# **Proposal Request**

Polk Stanley Wilcox 509 W. Spring St., Ste 150 Fayetteville, AR 72701 Architect's Project Number: 993A Proposal Request Number: 089R Proposal Request Date: 03.06.2025

# PROPOSAL REQUEST 089R

# Green Roof Devices and High Roof Security Cameras Ver. 2

Contents:
TELECOM SITE
PLAN - ROOF

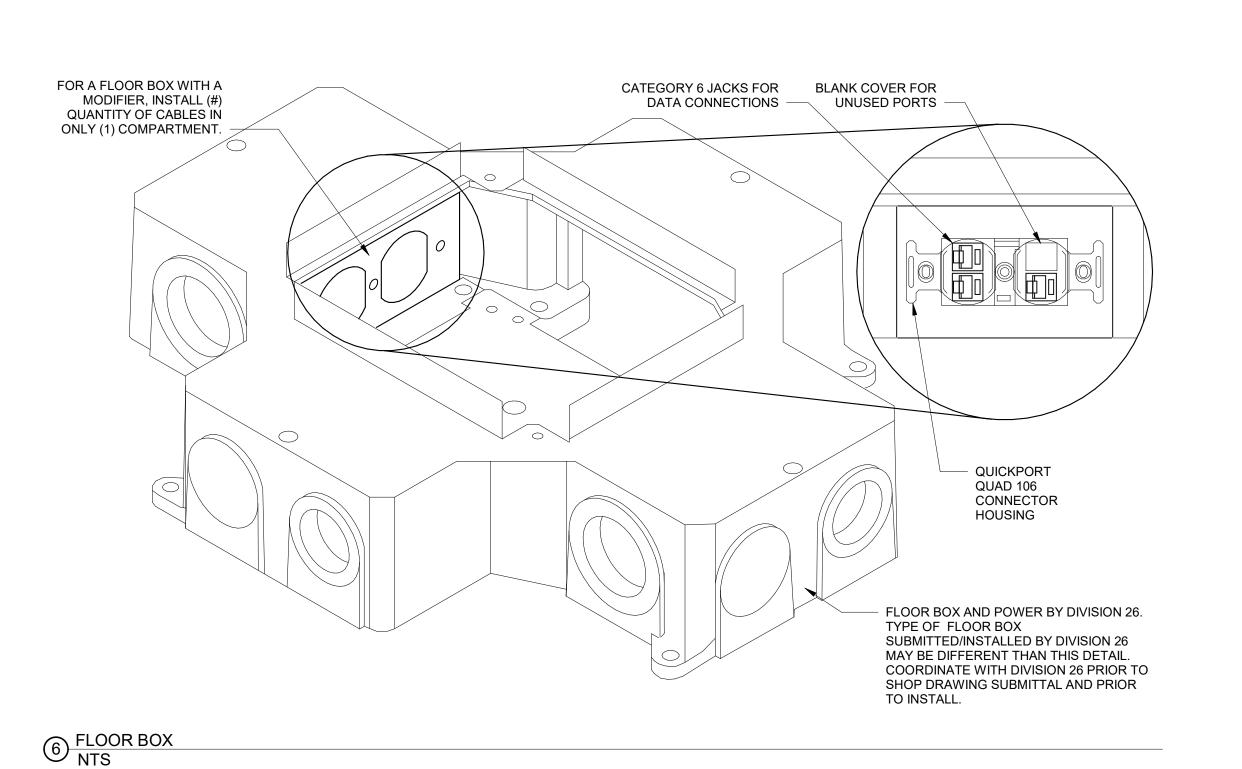
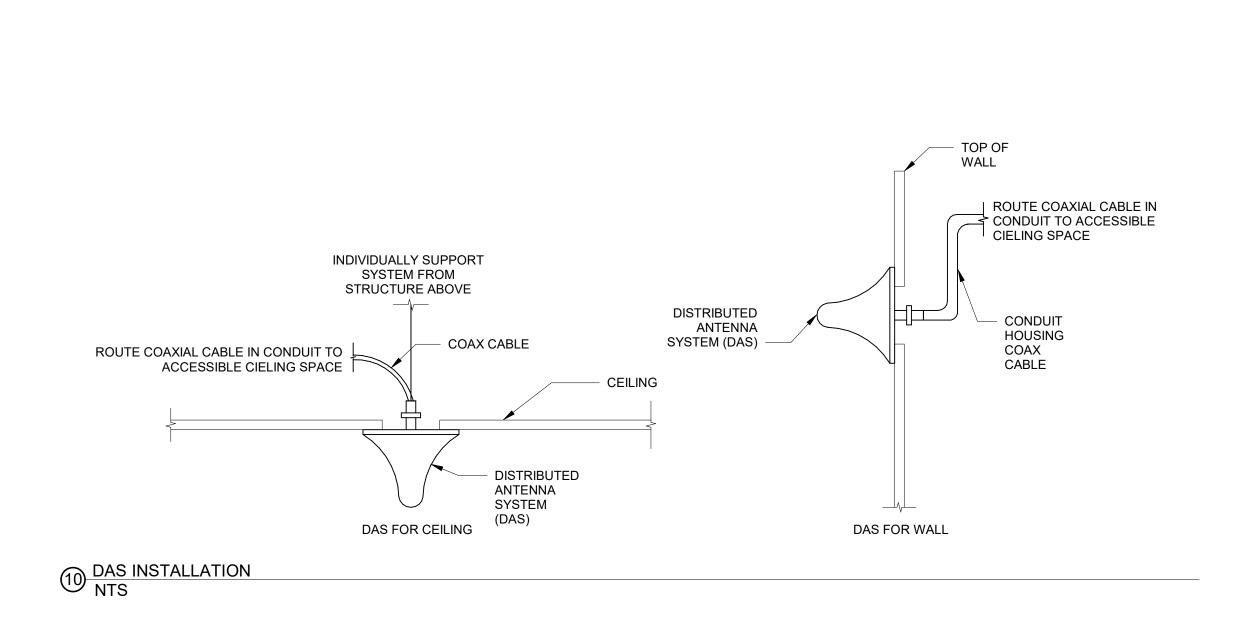
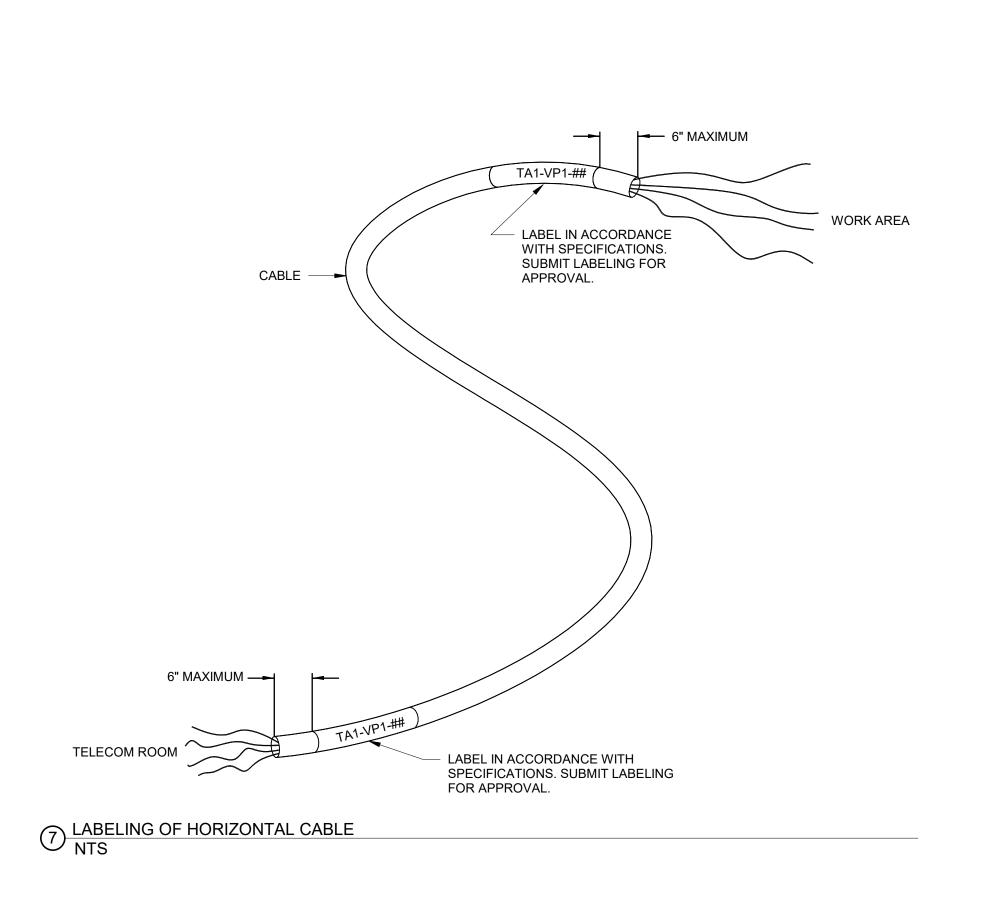
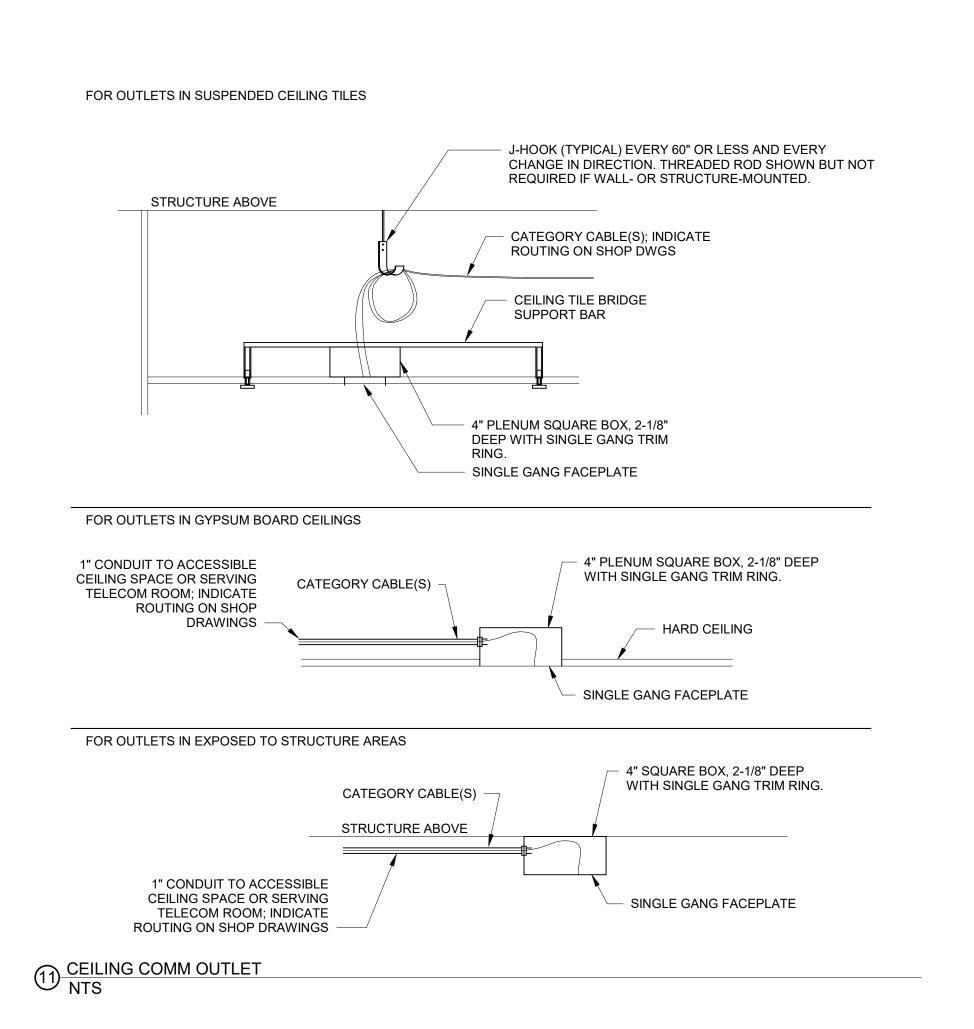
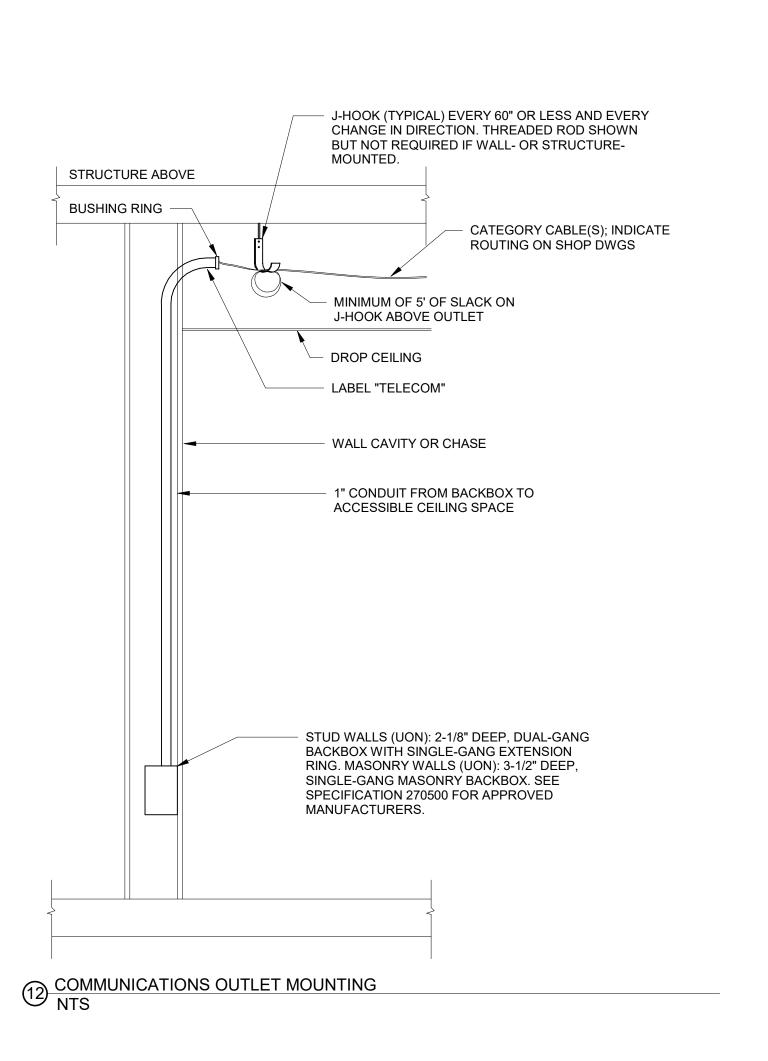
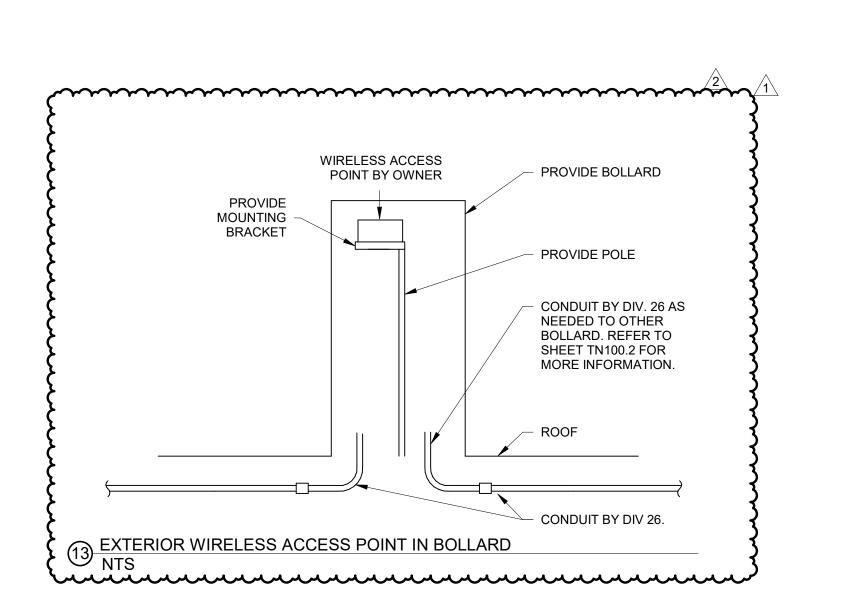
- a) Revised Sheet **TN000** with original issue date 02.24.2023 and revised date 03.06.2025.
  - Added note for wireless access points to legend.
- b) Added Sheet TN100.2 with issue date 12.12.2024.
  - Added 5 wireless access point bollards to green roof.
  - Added conduit, pull box, and cabling for wireless access points.
- c) Revised Sheet **TN500** with original issue date 02.24.2023 and revised date 03.06.2025.
  - Added Exterior Wireless Access Point in Bollard detail.

Contents:
SECURITY LEVEL 5 PLAN ROOF AREA A

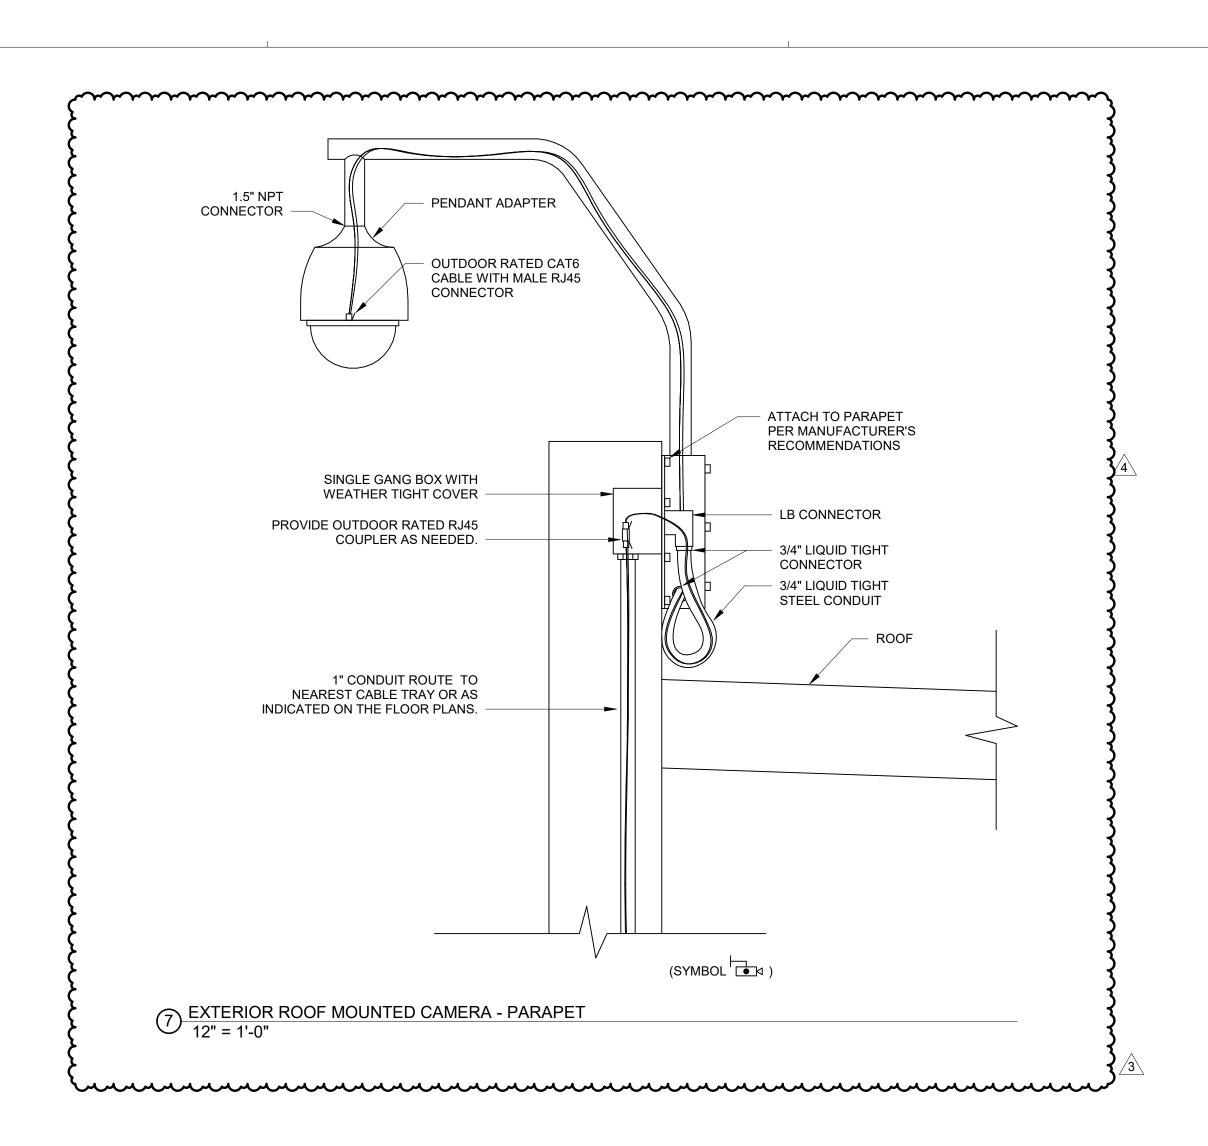
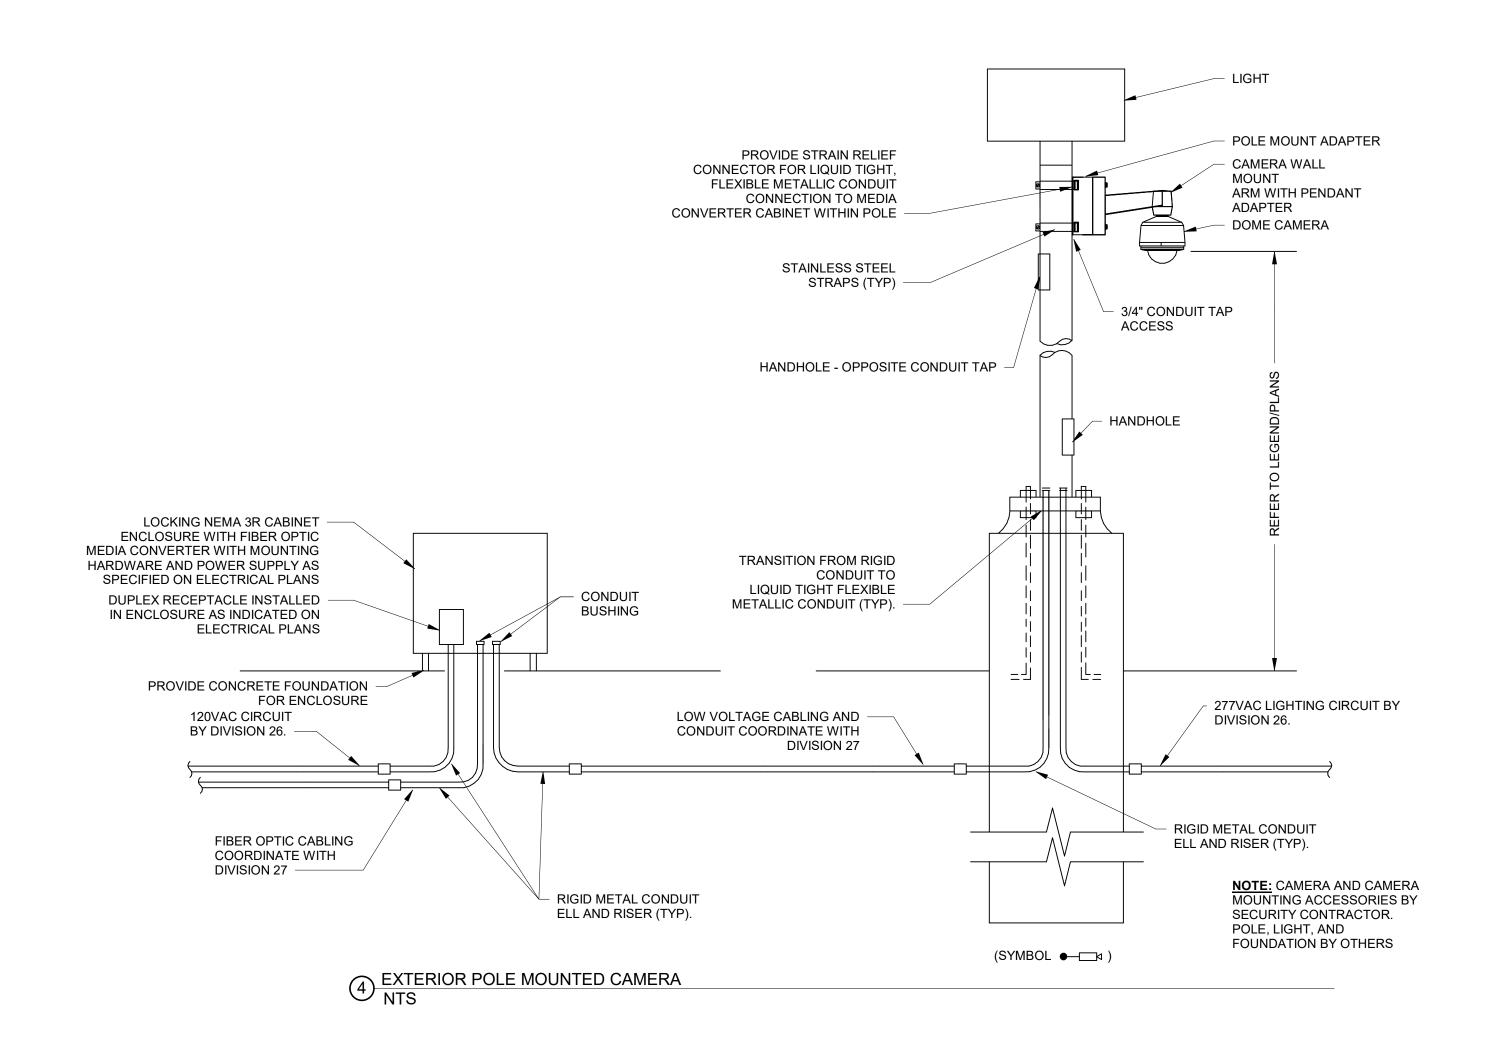
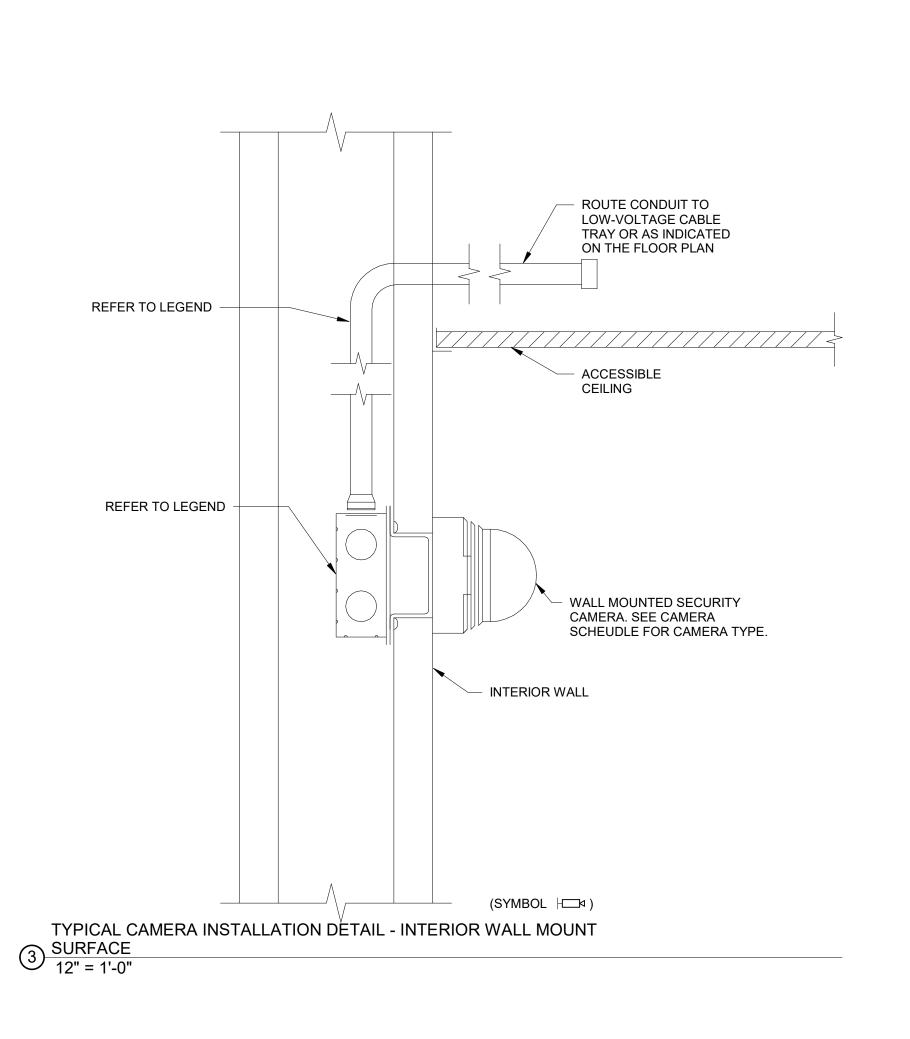
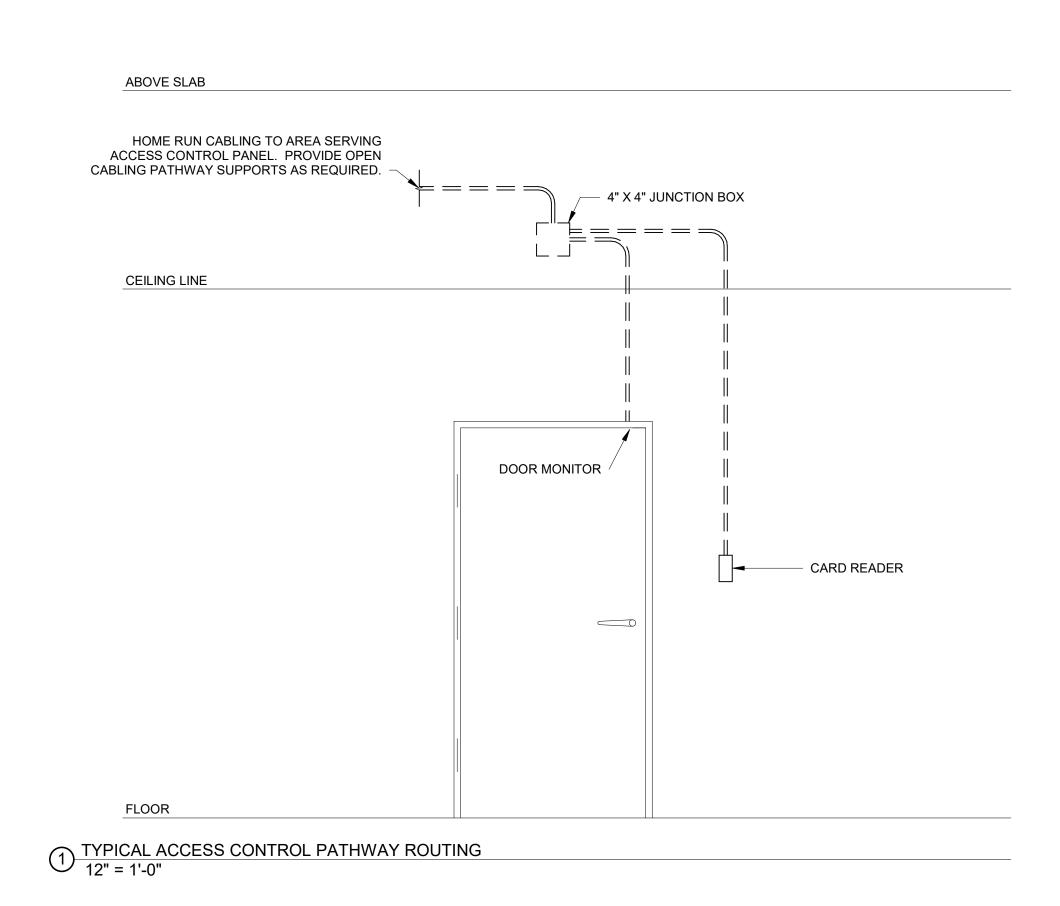
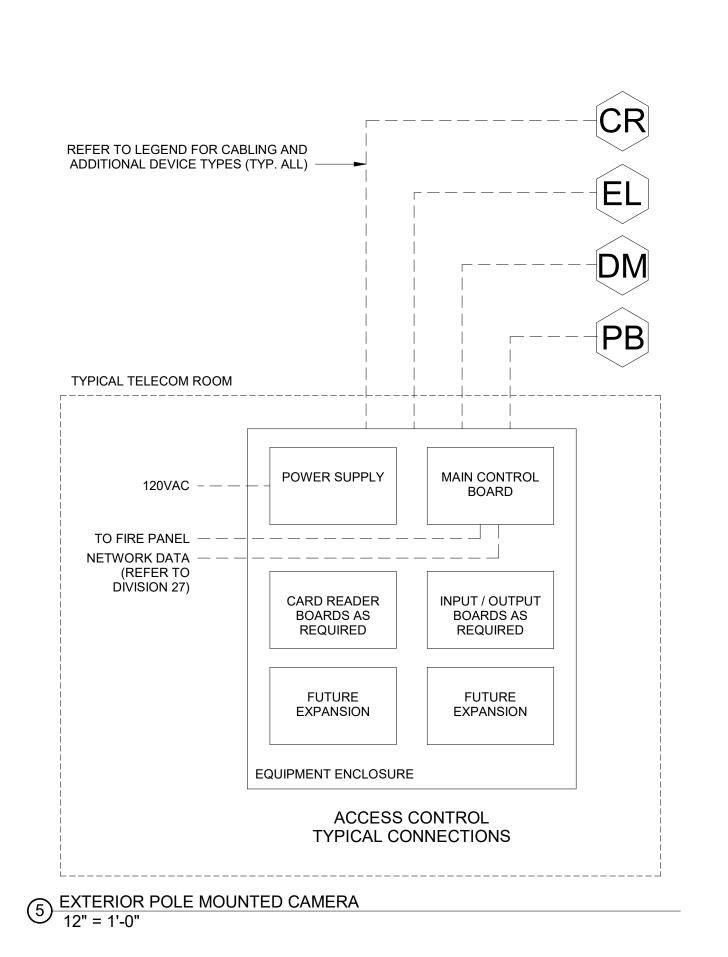
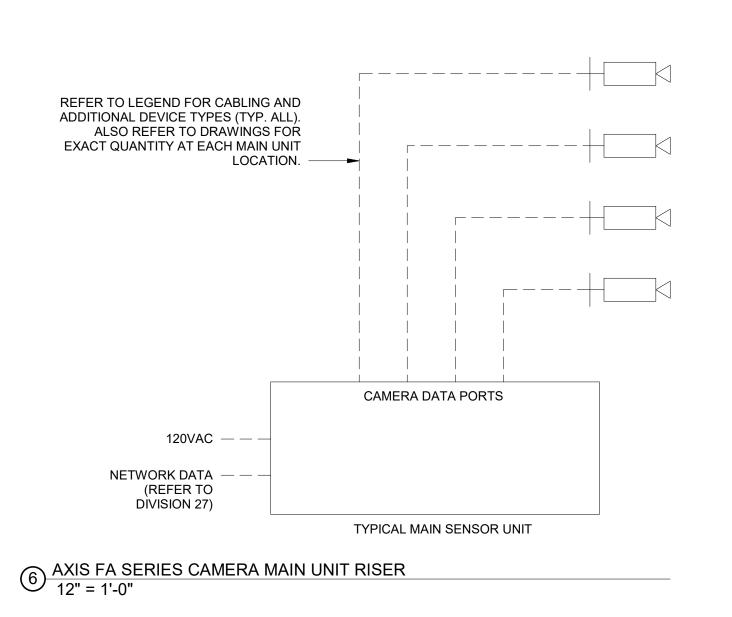
- a) Added Sheet **TY105A** with issue date 03.06.2025.
  - Added three cameras to Roof Plan Section A for surveilling Green Roof, Area B, of Roof Plan. Revised mounting location of Northeast Rooftop Camera.
- b) Revised Sheet **TY500** with original issue date 02.24.2023 and revised date 03.06.2025.
  - Revised sheet to include Details for Parapet mounting guidelines for Rooftop Cameras.
